Floor Plan

City of Puyallup
Development & Permitting Services
ISSUED PERMIT

PRCT120240912

Site Plan
 Parcel NO: 0419047027
 8704 9th St SW
 Puyallup, WA 98815
 Lot Area: .765 Acres
 Total Bldg Coverage: 2,536 SQFT

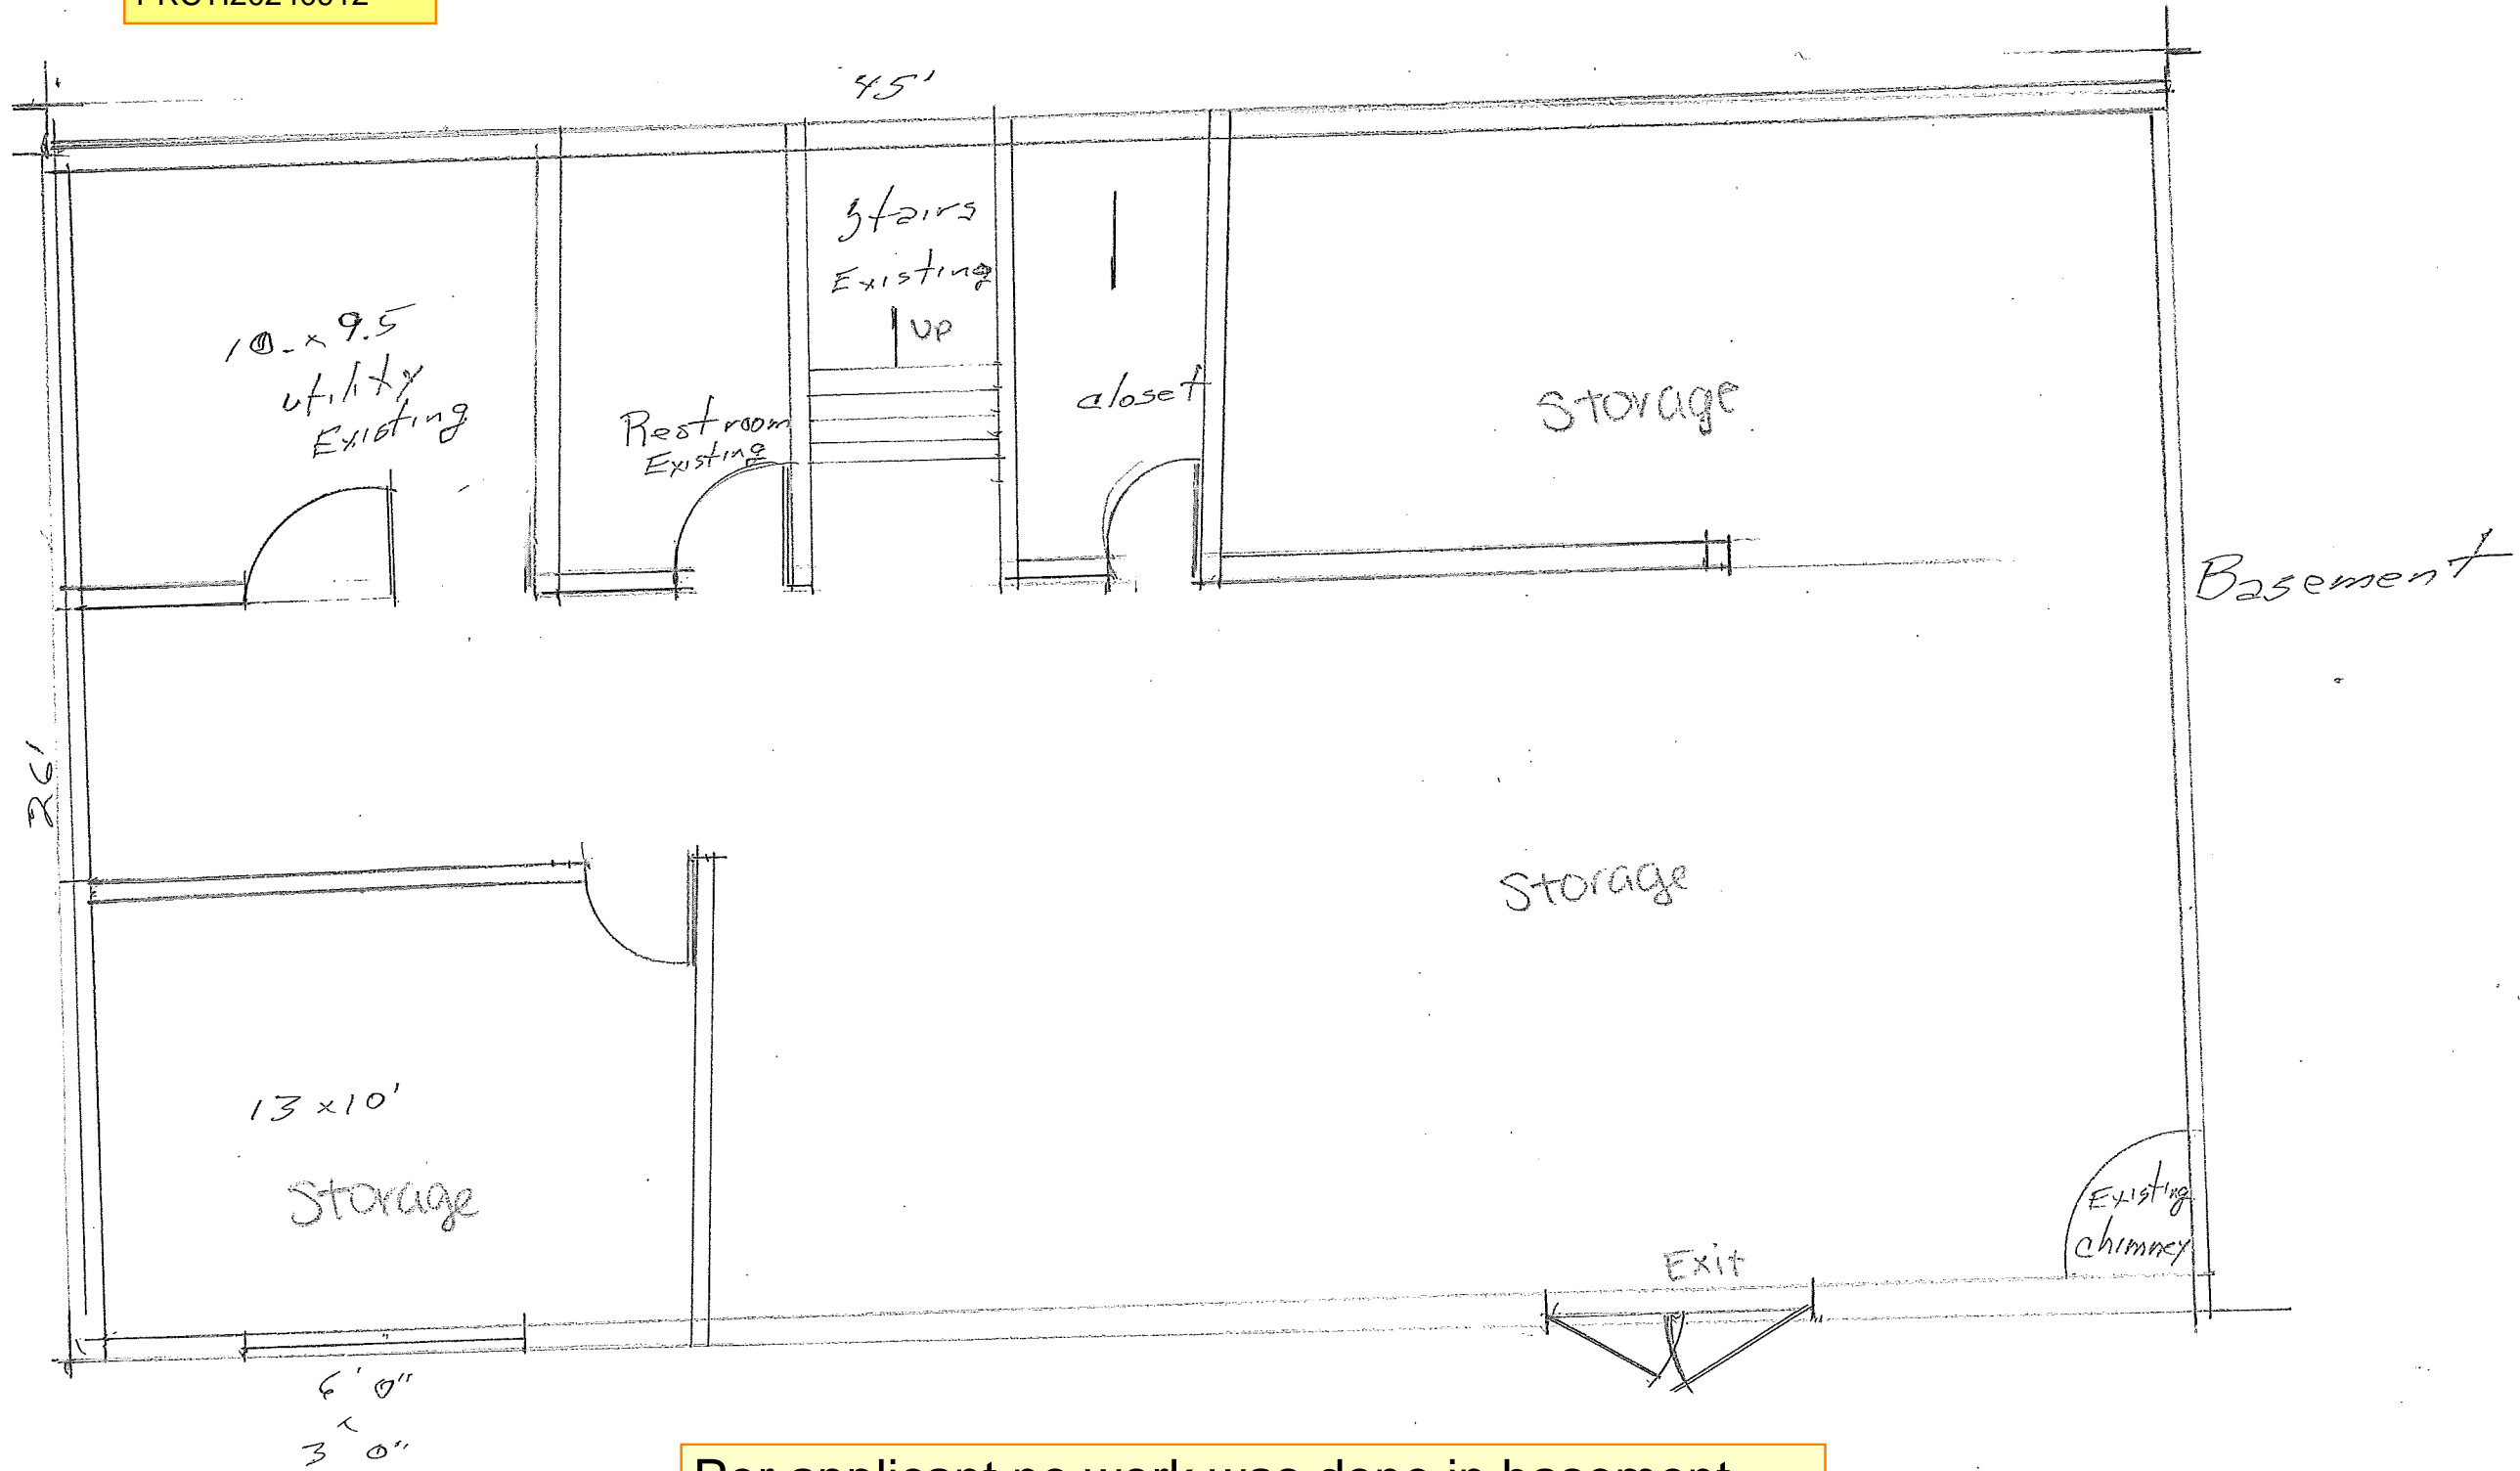
Provide documentation for inspection discussed at counter to meet 2021 WSEC of min 0.30 u-factor for all new windows replaced.

Met with applicant at counter - stated no interior walls were modified only cosmetic upgrades, flooring, painting, cabinet replacement etc.

Per applicant - no plumbing or mechanical work was installed

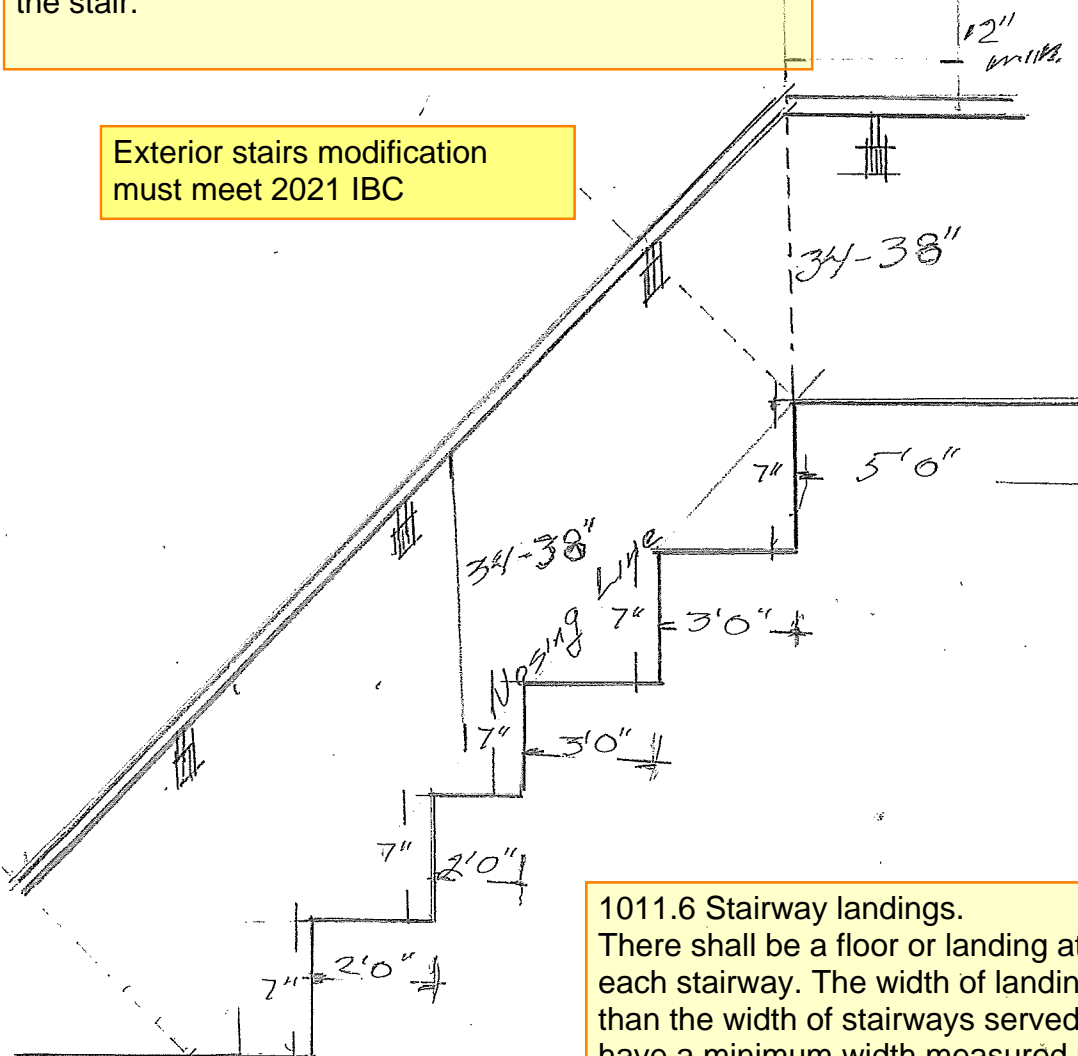
Per applicant no work was done in basement and area to be used as storage. If new owner/tenant to use differently they will obtain their own tenant improvement permit for all modifications.

1011.5.2 Riser height and tread depth.
 Stair riser heights shall be 7 inches (178 mm) maximum and 4 inches (102 mm) minimum. The riser height shall be measured vertically between the nosings of adjacent treads. Rectangular tread depths shall be 11 inches (279 mm) minimum measured horizontally between the vertical planes of the foremost projection of adjacent treads and at a right angle to the tread's nosing. Winder treads shall have a minimum tread depth of 11 inches (279 mm) between the vertical planes of the foremost projection of adjacent treads at the intersections with the walkline and a minimum tread depth of 10 inches (254 mm) within the clear width of the stair.

1011.11 Handrails.
 Stairways shall have handrails on each side and shall comply with Section 1014.

1014.2 Height.
 Handrail height, measured above stair tread nosings, or finish surface of ramp slope, shall be uniform, not less than 34 inches (864 mm) and not more than 38 inches (965 mm). Handrail height of alternating tread devices and ships ladders, measured above tread nosings, shall be uniform, not less than 30 inches (762 mm) and not more than 34 inches

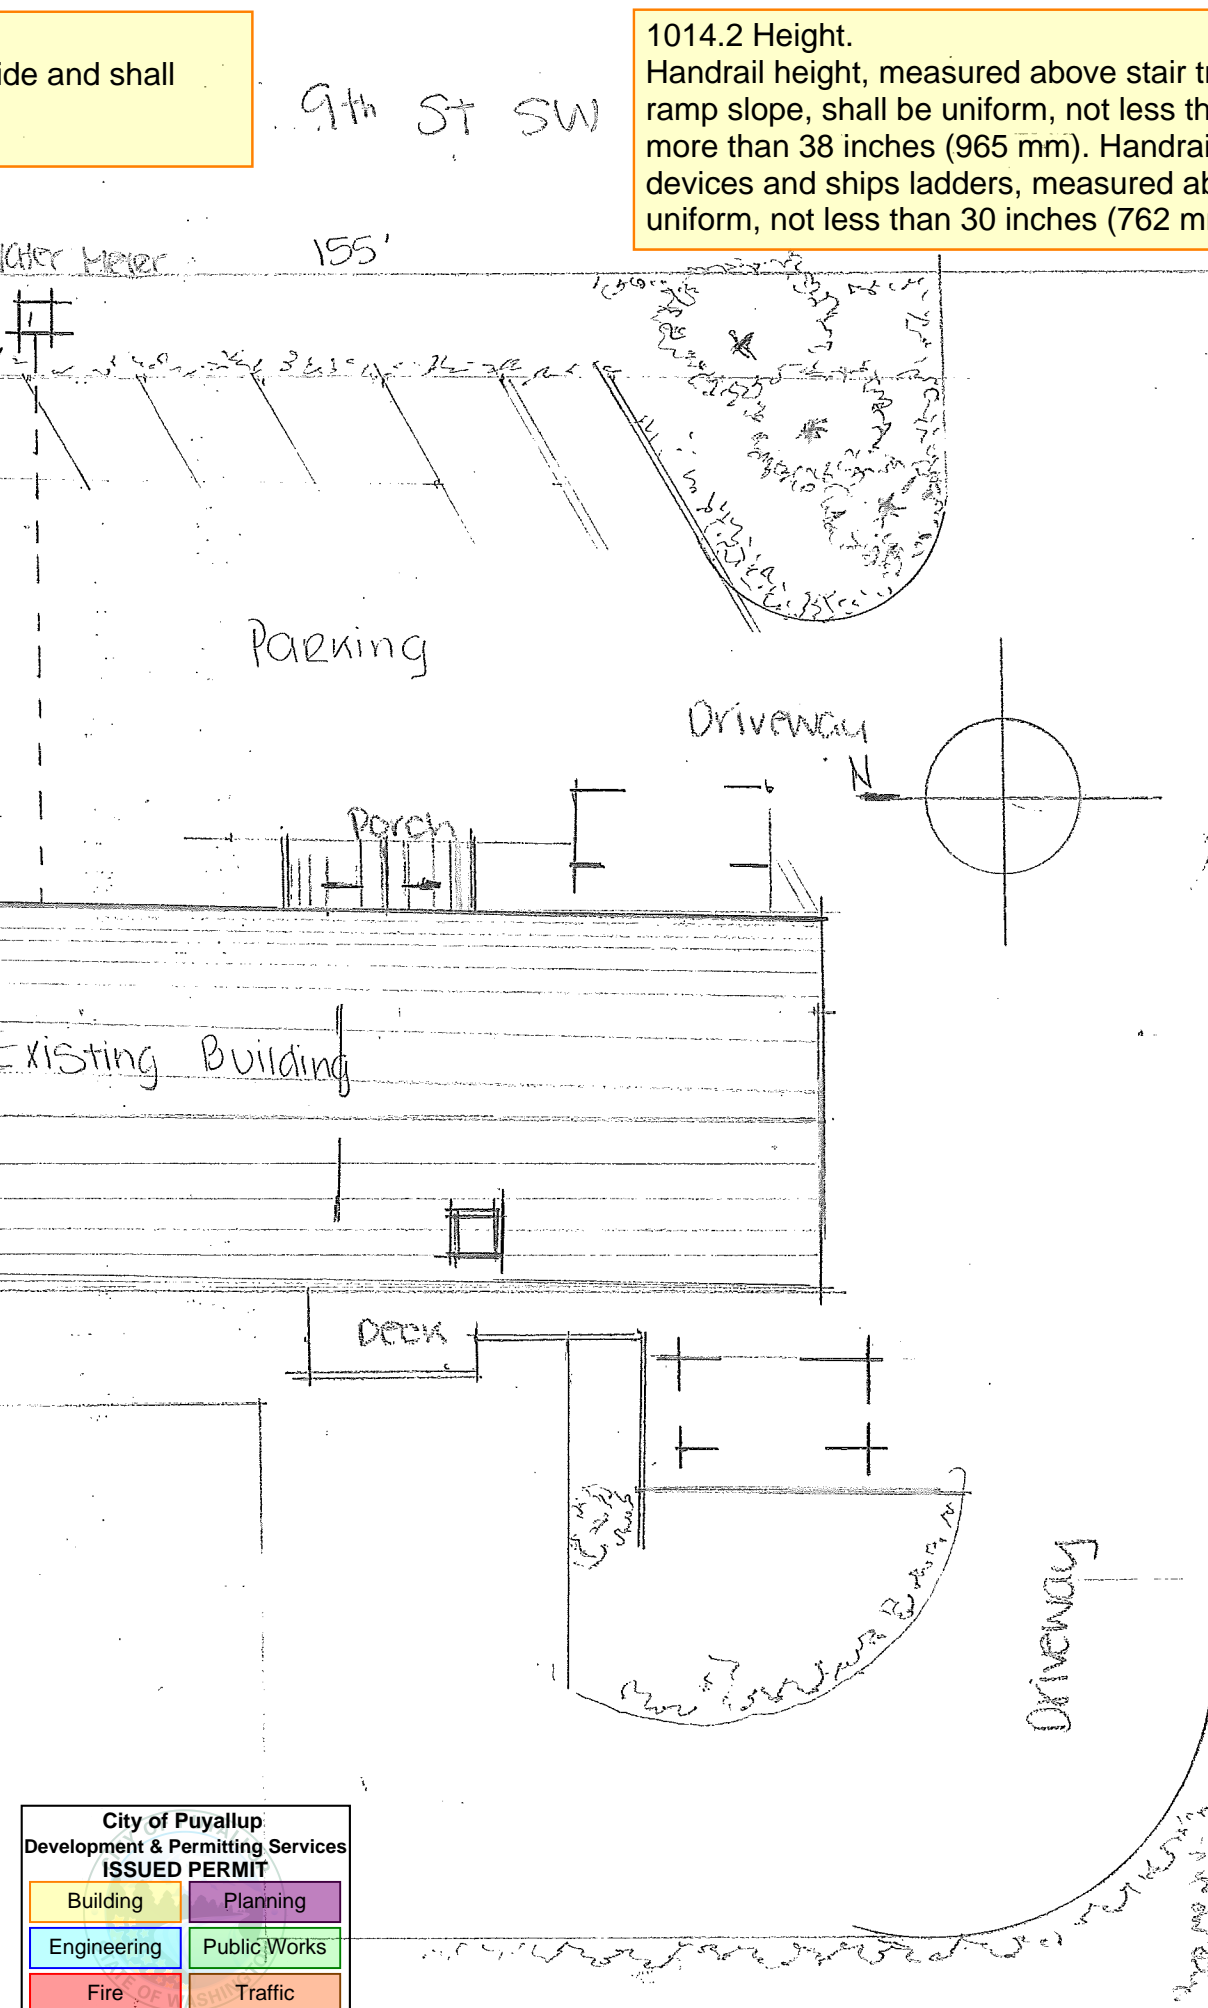
Parking was questioned, Aerial view clarified it was previously existing per Shane Pieren.

Exterior stairs modification must meet 2021 IBC

1011.6 Stairway landings.
 There shall be a floor or landing at the top and bottom of each stairway. The width of landings shall be not less than the width of stairways served. Every landing shall have a minimum width measured perpendicular to the direction of travel equal to the width of the stairway. Where the stairway has a straight run the depth need not exceed 48 inches (1219 mm). Doors opening onto a landing shall not reduce the landing to less than one-half the required width. When fully open, the door shall not project more than 7 inches (178 mm) into a landing. Where wheelchair spaces are required on the stairway landing in accordance with Section 1009.6.3, the wheelchair space shall not be located in the required width of the landing and doors shall not swing over the wheelchair spaces.
